Circuit (for current sense)

Circuit (for voltages)

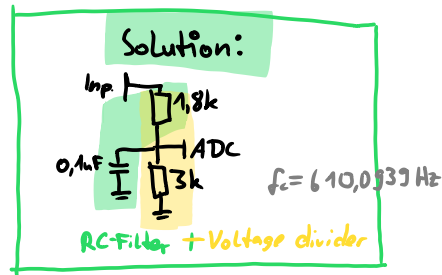
ISSUE:
Won't R27 & R25 form a 3.6k resistor and change the Voltage Divider scaling?

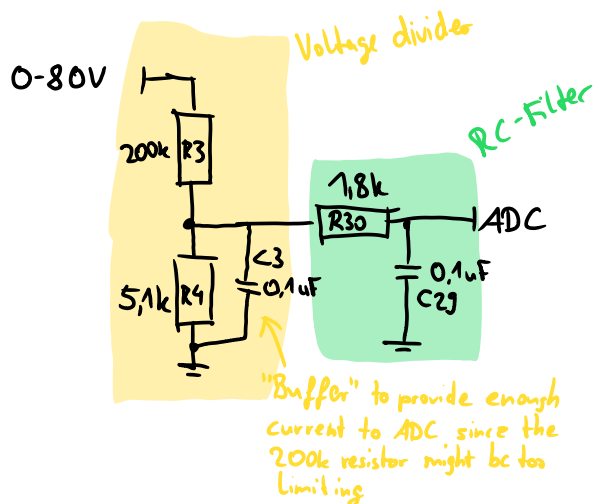
ISSUE:
Doesn't C3 form another RC-Filter with R3?

ISSUE 2:
R3 & R4 change the RC-filters corner frequency

SOLUTION
Just remove C3
